Office Action Summary	Application No.	Applicant(s)	
	10/529,370	ORIZARIS, VASILIOS	
	Examiner	Art Unit	
	KAITLIN A. WILSON	3636

DETAILED ACTION

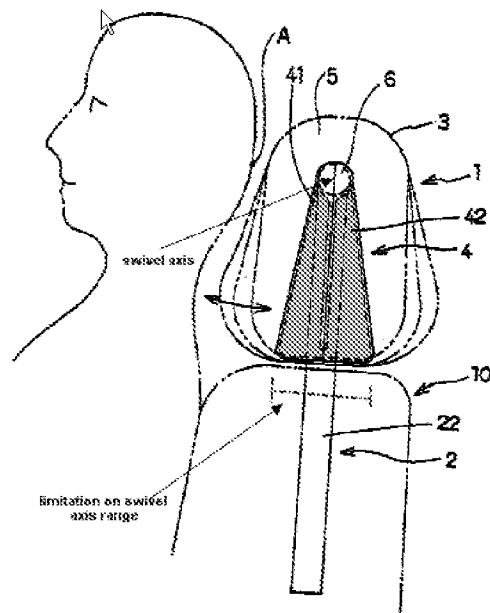
7. In re Claim 16, with reference to Figure 1, Nakane et al. disclose a motor vehicle seat comprising:

- a seat back with a seat back support (10),
- a head support (1) attached to the seat back support (10) by a connection element (22)
- wherein the head support (3) defines an impact plate (4) on a side facing a vehicle passenger with a basically flat area (Figure 2) assuring secure retention of a head of a vehicle passenger during an accident
- wherein the impact plate (4) is positioned so for limited swivel (shown below) around a horizontal swivel axis (shown below, 6), so as guarantee two-dimensional contact between the head of the vehicle passenger and the impact plate during an accident.
- wherein the swivel axis (shown below) of the impact plate (4) is positioned in the vicinity of the head of the vehicle passenger on the impact plate (4)

8. The examiner notes that the impact plate (3) would inherently make, two-dimensional contact of the head on the head support (3) in the event of an accident due to the adjustable nature of the head support (3).

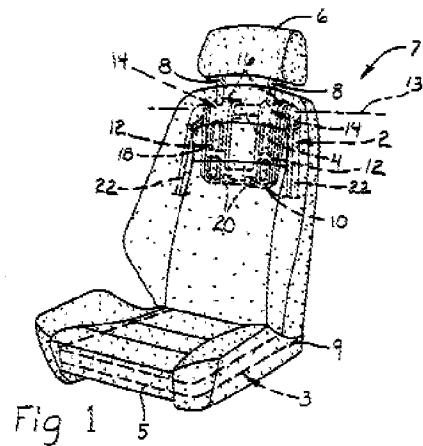
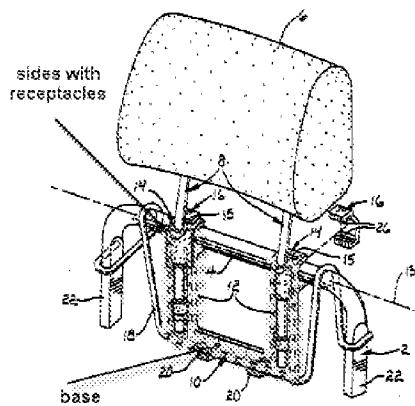
9. Nakane et al. fail to disclose an element aligned in the seat back, the element having a base facing the vehicle passenger, a pair of sides that receive the connection element and an open side oriented away from the vehicle passenger to an area behind the motor vehicle seat.

10. However, with reference to Figure 1, Viano et al. disclose a seat back with two side supports (12) down the length of the back, with two support elements (shown below).

11. Additionally, with reference to Figure 4, Viano et al. disclose a straight base area (34) with the attachment portions for the element on the back of the plate, opening outward away from the passenger.

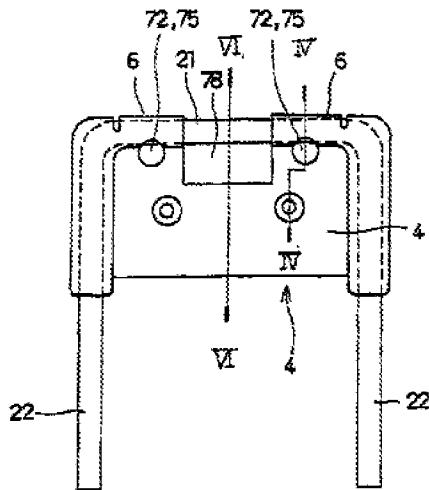
15. In re Claim 18, with reference to Figure 2, Nakane et al disclose that the connection element (22) is curved (paragraph 0018).

16. In re Claim 19, with reference to Figure 1, Nakane et al. discloses that independent of the position of the seat back (10) as well as the head support (3), the head support (3) provides a support of the head (0008), and that the radius of the

connection element (22) and the forward deployed position in relation to an upper body of the vehicle passenger.

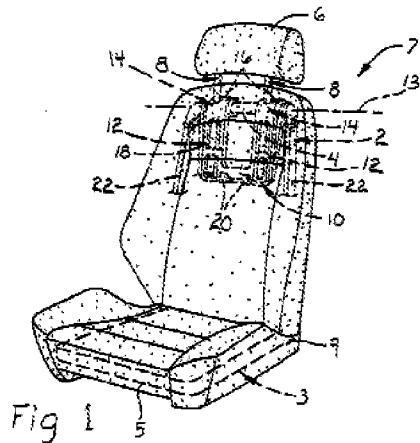
19. However, with reference to Figure 1, Viano et al. disclose a seat back with two side supports and down the length of the back, thus a cross-section of the seat would be in the shape of a U structure, but fails to disclose that the back support is included in the U-shaped structure.

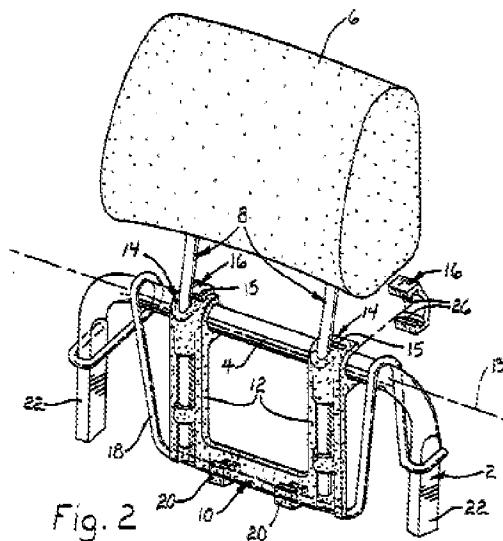
21. In re Claim 21, with reference to Figure 2, Viano et al. disclose wherein the base (10) is longer than the side flanks (12).

22. In re Claim 22, with reference to Figure 2, Viano et al. disclose that the transverse traverse has a pair of receptacles for each connection element (22).

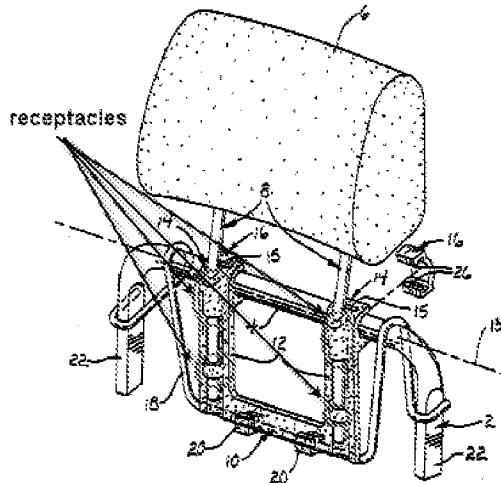
23. The examiner notes that the holes within the side portions are considered to be equivalent to the applicant's receptacles.

24. In re Claim 23, with reference to Figure 2, Viano et al. disclose that each receptacle is made in one of the side flanks (12).
